DUKE POWER COMPANY

Re: McGuire Nuclear Station  
Docket Nos. 50-369, 50-370

As requested in a May 30, 1984 telephone conversation between Bernard Turovlin, NRC/ONRR, and W. H. McDowell, Duke Power Company, attached is additional information concerning the McGuire spent fuel pool rerack modifications. If there are further questions regarding this matter, please contact us.

DUKE POWER COMPANY  
McGUIRE NUCLEAR STATION  
SPENT FUEL POOL RERACK MODIFICATIONS  
ADDITIONAL INFORMATION

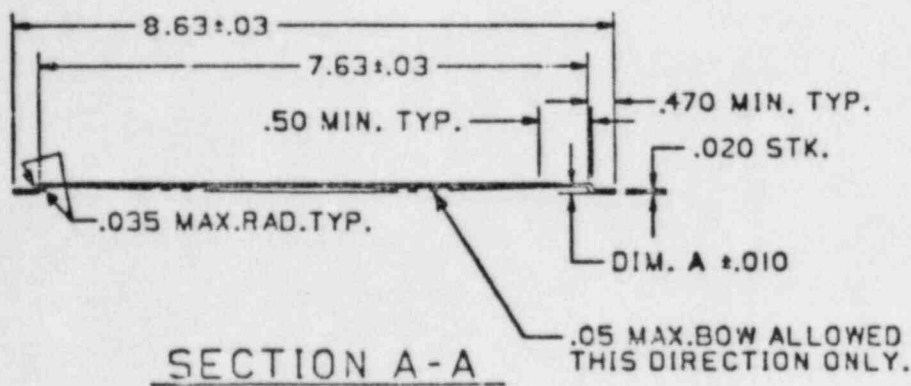
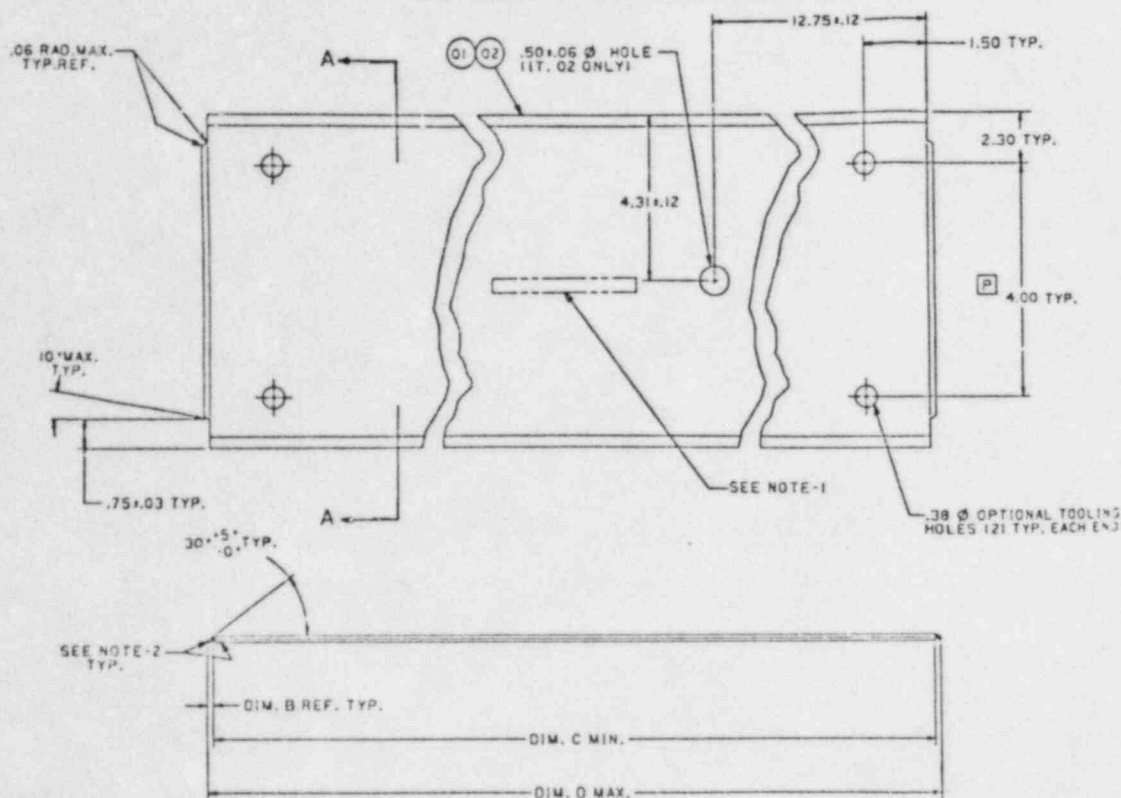
As detailed in the attached sketch, each set of 3 coupons is to be mounted between two 75 mil stainless steel plates. This arrangement closely resembles that of the boraflex mounted on the rack cells. Wrapper and cell material is also 75 mil stainless.

Coupon testing will include a visual inspection for evidence of corrosion, cracking, or crumbling. The following physical and mechanical properties will be measured: width, thickness, weight, specific gravity,  $B^{10}$  content, hardness (as an indicator of embrittlement), and tensile strength. Additionally, a measurement of neutron attenuation will be recorded for each specimen. All tests will be consistent with the original qualifying tests of each batch. A sketch of surveillance specimen details is included as Attachment 2.

MC GUIRE NUCLEAR STATION, UNITS 1 & 2  
 SPENT FUEL RACKS - WRAPPER PLATES

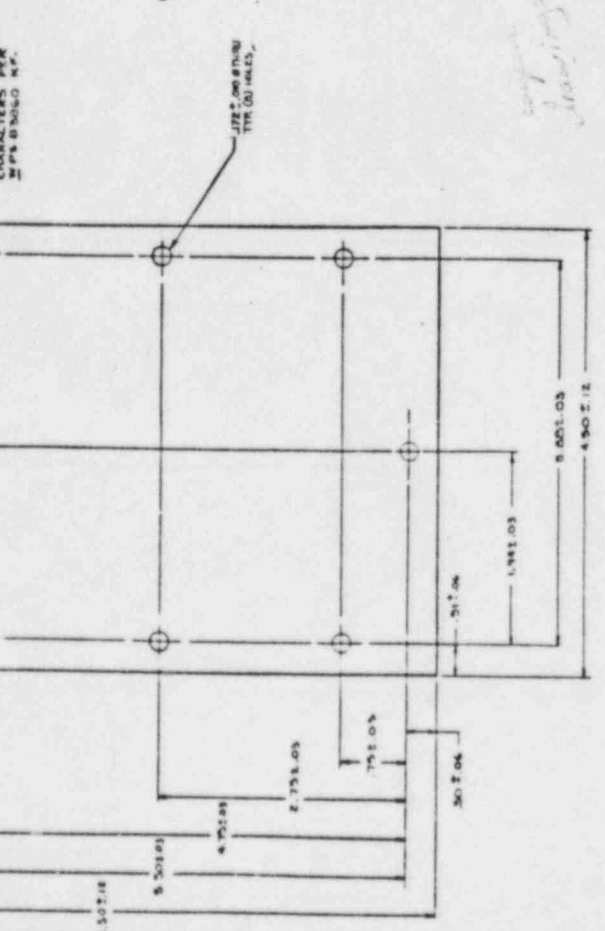
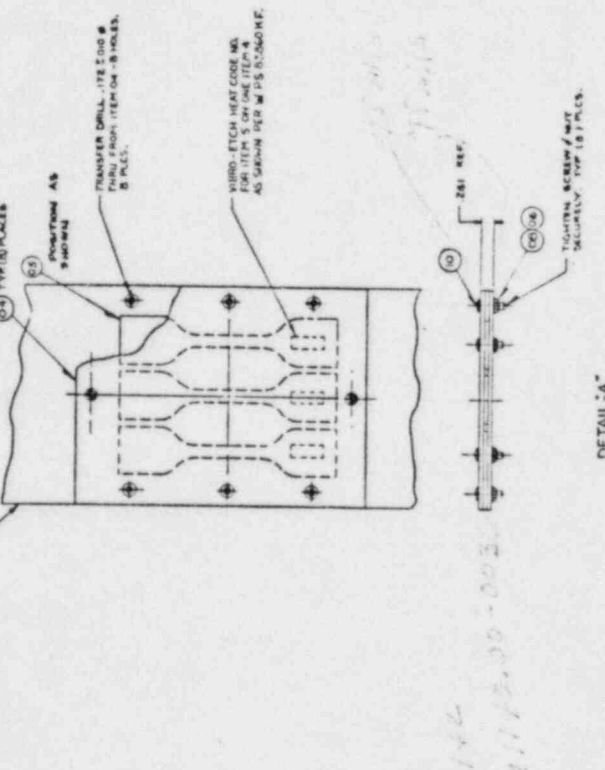
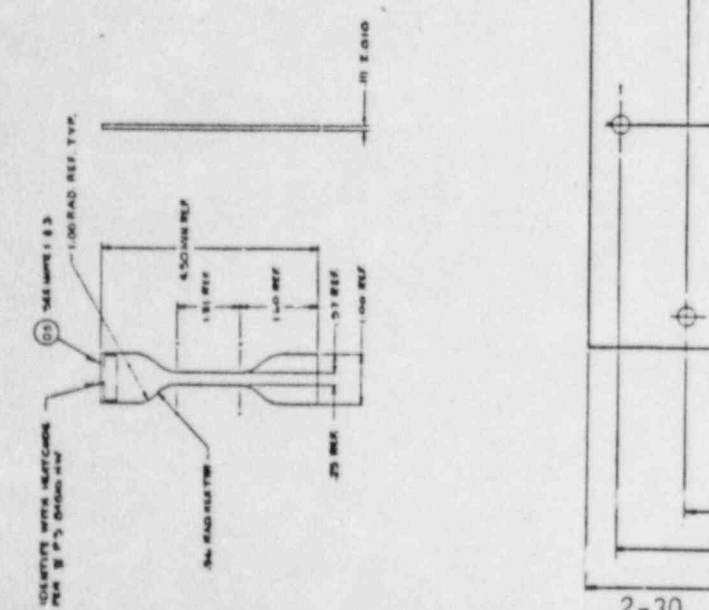
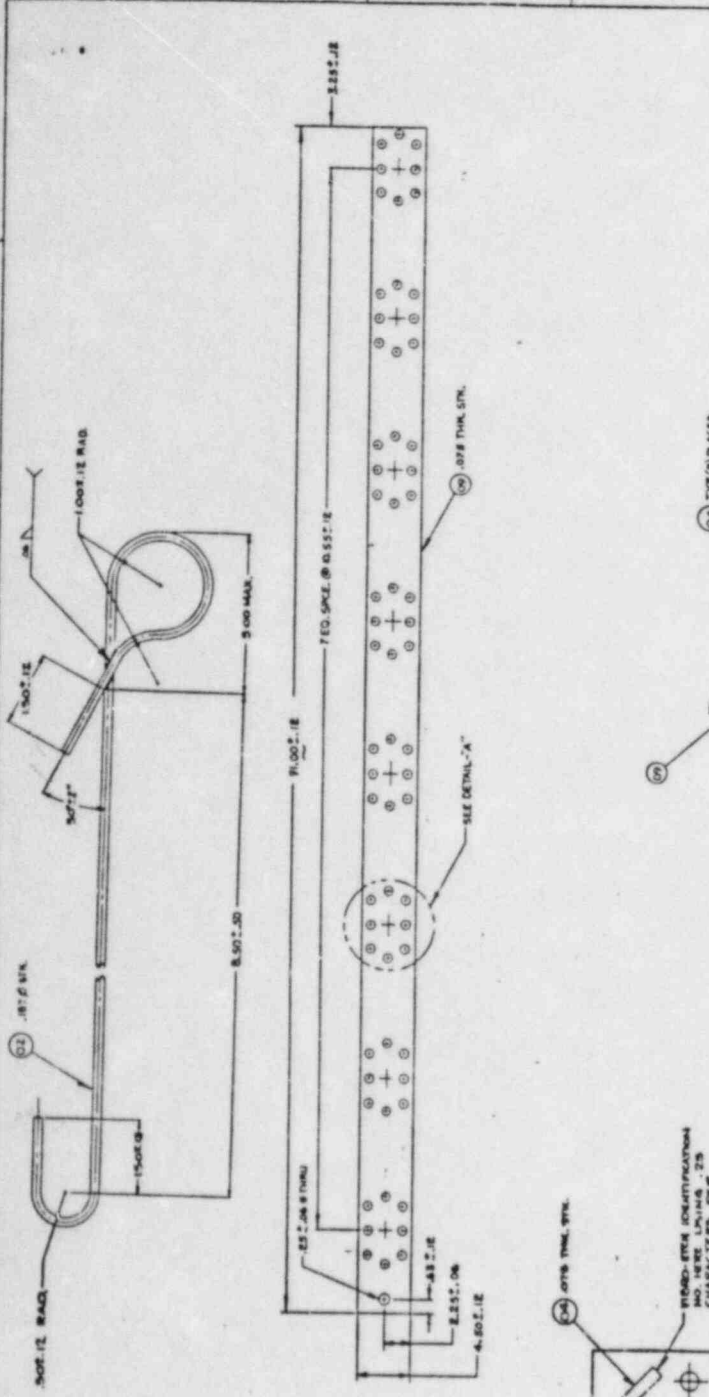
A sketch of the wrapper plate details is included as Attachment 1.

2. Poison material venting occurs through cutouts at corners of the wrapper plate. The wrapper is spot welded to the cell wall along the vertical joint between the wrapper and cell.
3. There has been no change in the spent fuel pool water boron concentration. The proposed technical specification changes include a surveillance requirement to verify boron concentration once per 31 days. The boron concentration in the spent fuel pool is to be maintained at greater than or equal to 2000 ppm.
4. Details of the McGuire neutron poison surveillance program are as follows:
